ENERGY NORTHWEST

February 8, 2010
GO2-10-024

**Subject: COLUMBIA GENERATING STATION, DOCKET NO. 50-397
LICENSE AMENDMENT REQUEST TO CHANGE TECHNICAL
SPECIFICATIONS RELATING TO CONTROL ROD OPERABILITY AND
CONTROL ROD SCRAM ACCUMULATORS**

**LICENSE AMENDMENT REQUEST TO CHANGE TECHNICAL SPECIFICATIONS
RELATING TO CONTROL ROD OPERABILITY AND CONTROL ROD SCRAM
ACCUMULATORS**

BASES (continued)

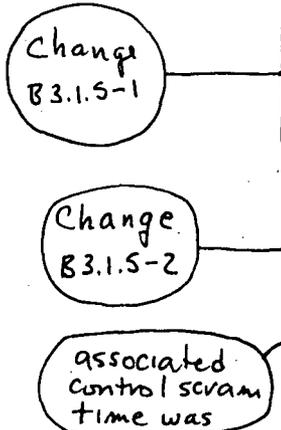
With one control rod scram accumulator inoperable and the reactor steam dome pressure ≥ 900 psig, the control rod may be declared "slow" (~~after declaring the average scram times in all two-by-two arrays associated with the control rod with the inoperable accumulator not within the limits of Table 3.1.4-1~~), since the control rod will still scram at the reactor operating pressure but may not satisfy the required scram times in Table 3.1.4-1. Required Action A.1 is modified by a Note, ^{indicating} ~~which clarifies~~ that declaring the control rod "slow" is ^{only applicable} ~~only applicable~~ if the ~~average scram times of the two by two arrays associated with the control rod with the inoperable accumulator are~~ ^{test} ~~within the limits of~~ Table 3.1.4-1 during the last scram time ~~surveillance~~. Otherwise, the control rod may already be considered "slow"

The control rod may be declared "slow" (~~after declaring the average scram time in all two-by-two arrays associated with the control rod with the inoperable accumulator not within the limits of Table 3.1.4-1~~), since the control rod will still scram using only reactor pressure, but may not satisfy the times in Table 3.1.4-1. Required Action B.2.1 is modified by a Note indicating that declaring the control rod "slow" ~~is only applicable~~ ^{applies} if the average scram times of the ~~two-by-two arrays associated with the control rod with the inoperable accumulator are~~ within the limits of

Change
B3.1.5-3

Change
B3.1.5-4
